JOML - Design  
Development

UNIVERSITY OF MINNESOTA  
HEALTH SCIENCES EXPANSION

PROJECT: JOML Complex Remodeling  
Phase I - Design Concept and Scheduling Phase

SUBJECT: JOML Complex Remodeling  
Design Development Review Meeting

# HEALTH SCIENCES SITE STORAGE ZONES

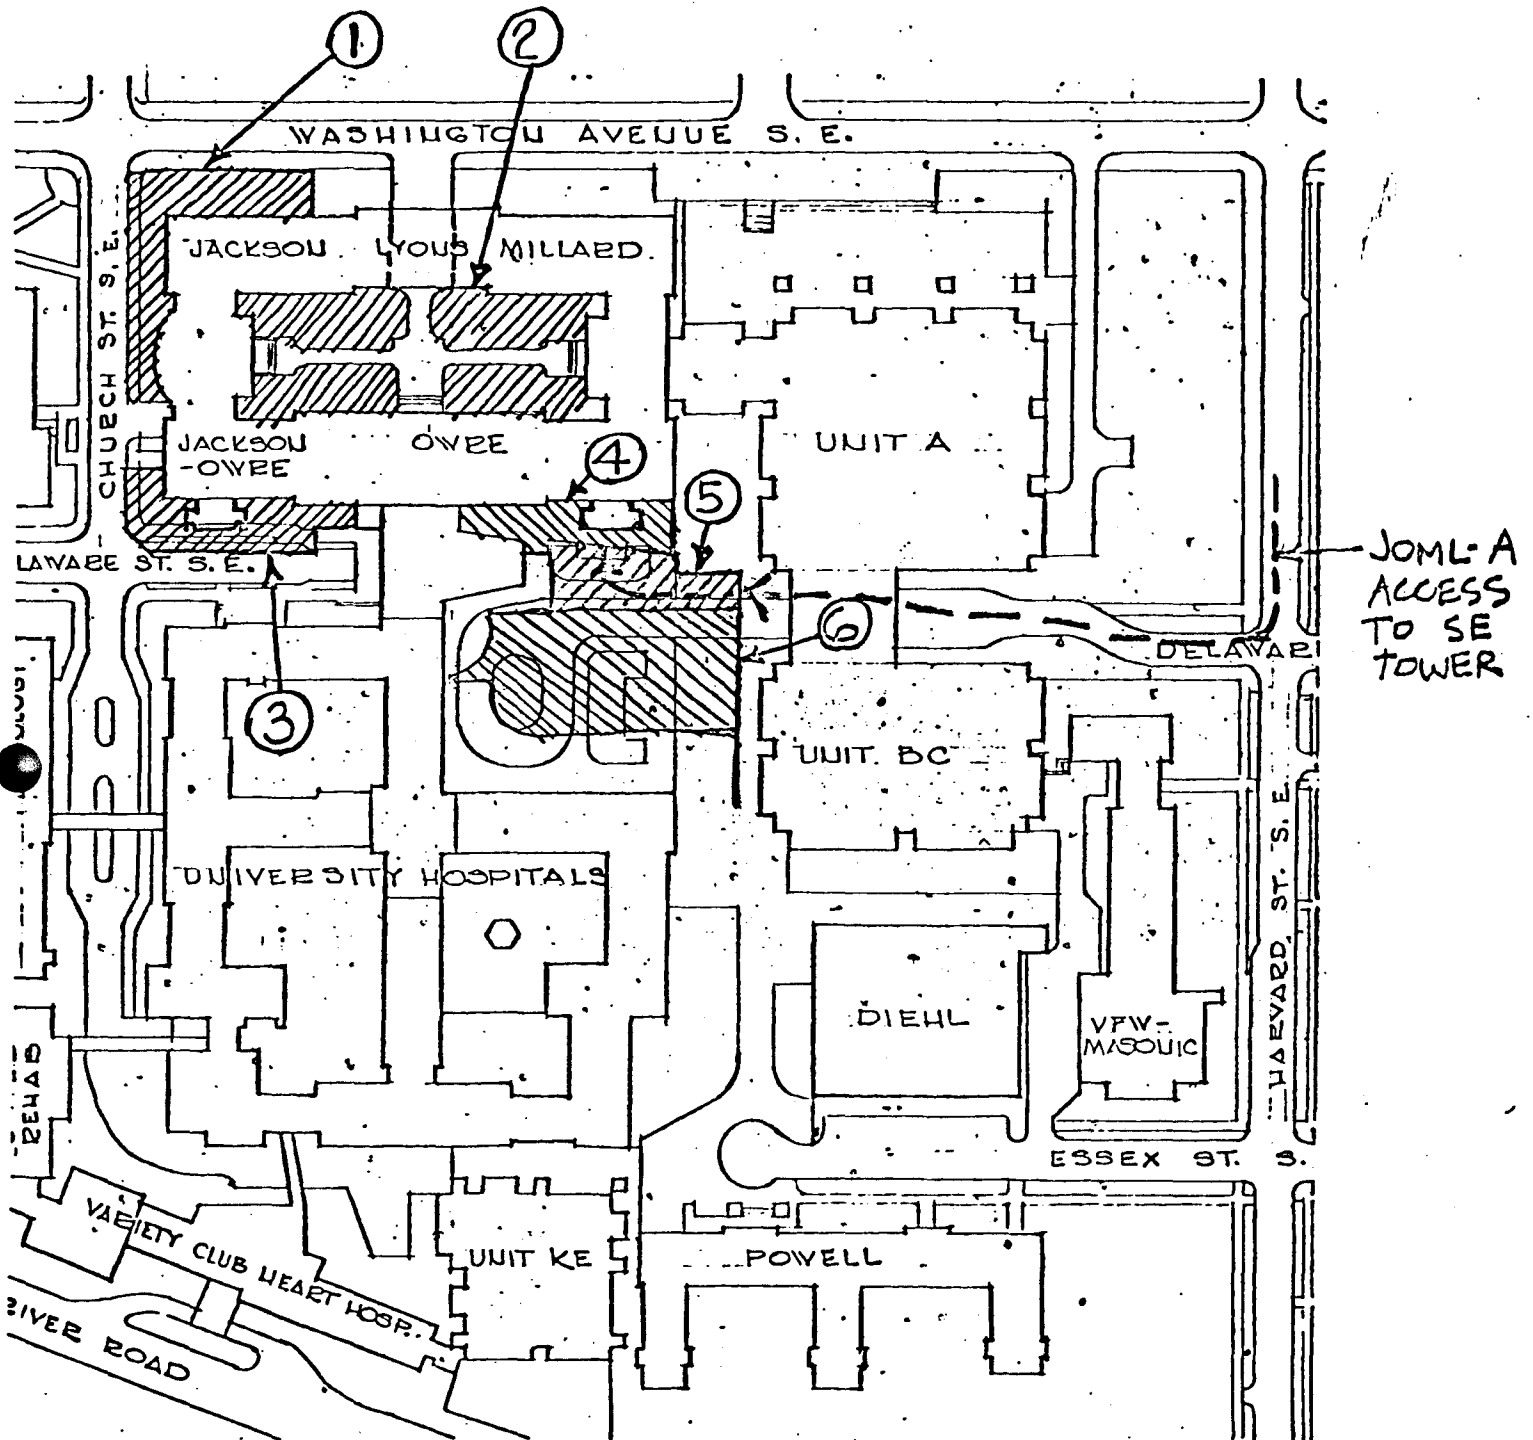
Jerry Olson presented a Site Plan indicating proposed storage areas for each phase of construction contracts: Surgical Pathology, Mortuary Science, JOML, B/C, etc. The construction of the SE tower must be coordinated with the B/C Contractor for access to space, storage of material, etc. All storage areas would be fenced by the affected contractor. Area 3 (SW tower area) would have the fence installed by the Mortuary Science Contractor but removed by the JOML - A Contractor. It is expected that the construction specification would require the use of a traffic director whenever materials are delivered to the site and to assure streets are open to traffic. Diagram included with this memo.

- ZONE 1 - SURG PATH CONTR
- ZONE 2 - JOML-B CONTR
- ZONE 3 - MORT SCI CONTR TILL 10CT 76; JOML-A CONTR THEREAFTER
- ZONE 4 - JOML-A CONTR; UNIT BC CONTR THEREAFTER
- ZONE 5 - UNIT BC CONTR; ACCESS GRANTED TO JOML-A CONTR
- ZONE 6 - UNIT BC CONTR

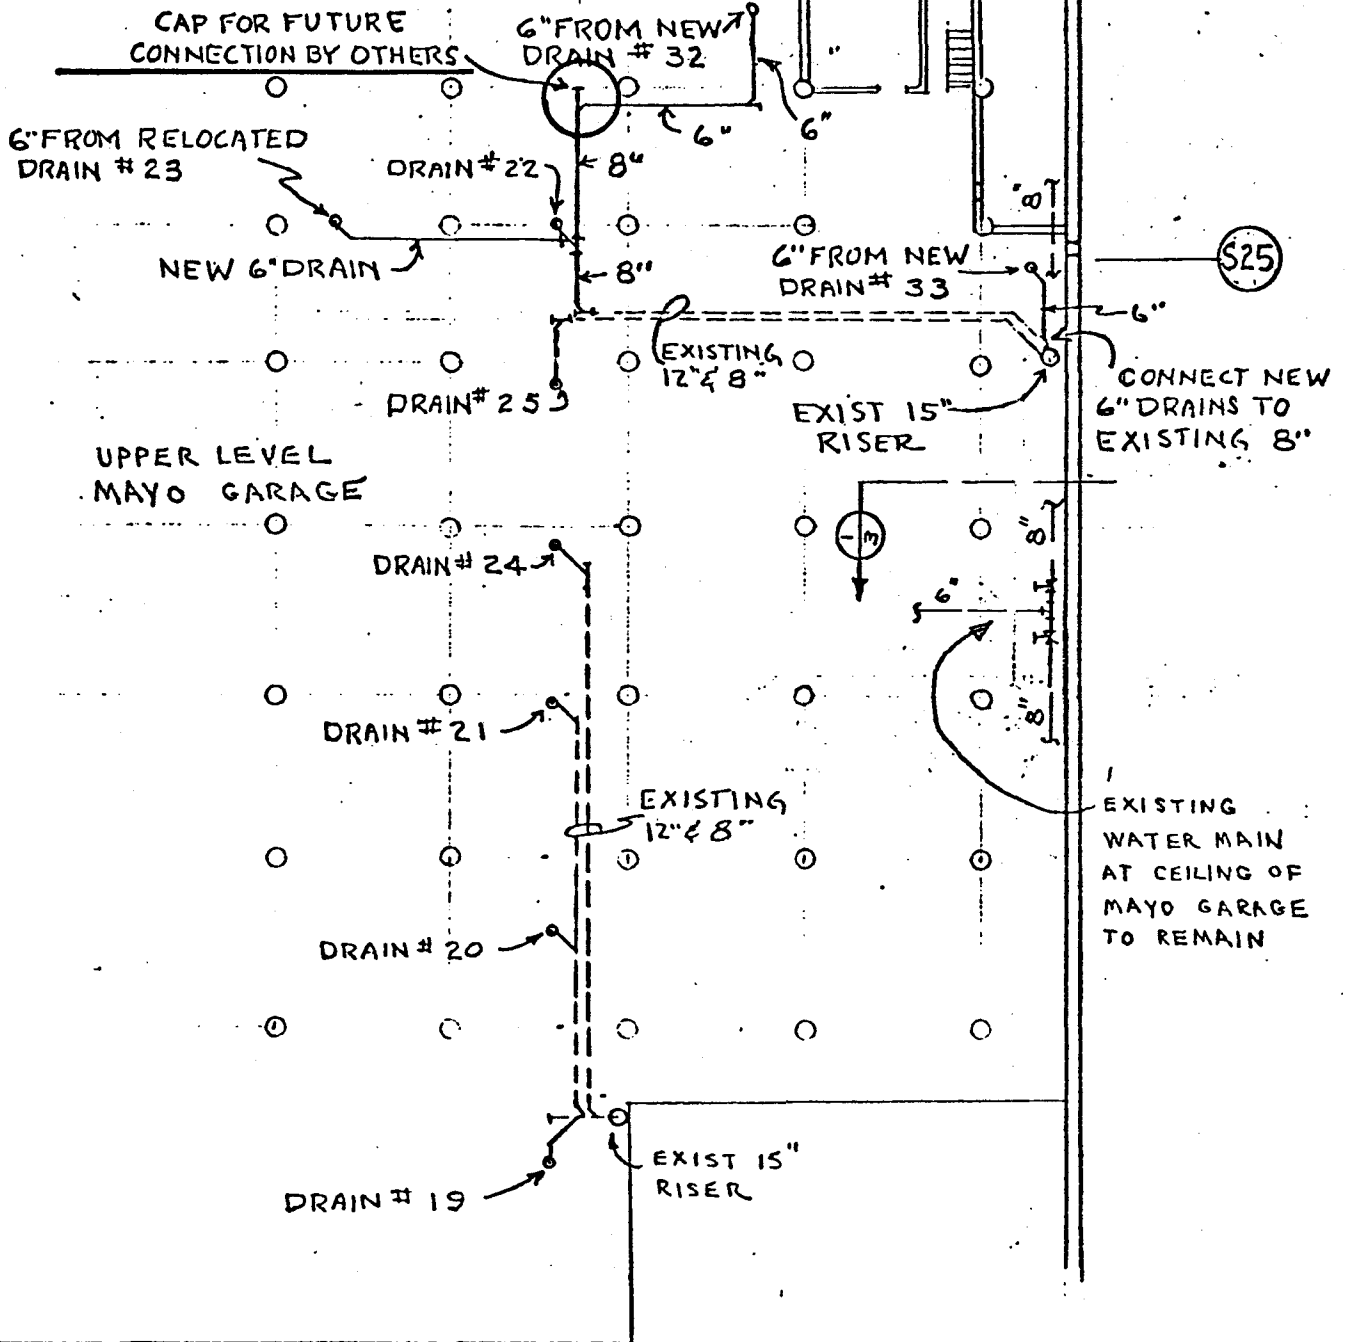
1. Cap the 3" rain water leader in the Mayo Graage near column C-9. This pipe will connect to an 8" drain furnished and installed under another contract. See attached drawing.
2. Specification Section 15130/2.1 requires that the mechanical subcontractor furnish all pipe sleeves.

Specification Section 03300/3.4 requires the General Contractor to install pipe sleeves furnished by others.
3. Locate 12"  $\emptyset$  pipe sleeves through floors as follows:
  - a. S.W. Tower: Locate pipe sleeve as shown on floor plans - Disregard Addendum #1.
  - b. S.E. Tower: Move pipe sleeve 1'-0-1/2" toward grid 8 instead of grid 9 as indicated in Addendum #1.
4. Locate top of sump flange (in the sub-basement of the S.W. Tower) flush with the concrete floor finish. Keep threaded holes clear of concrete to allow fastening of cover to flange.
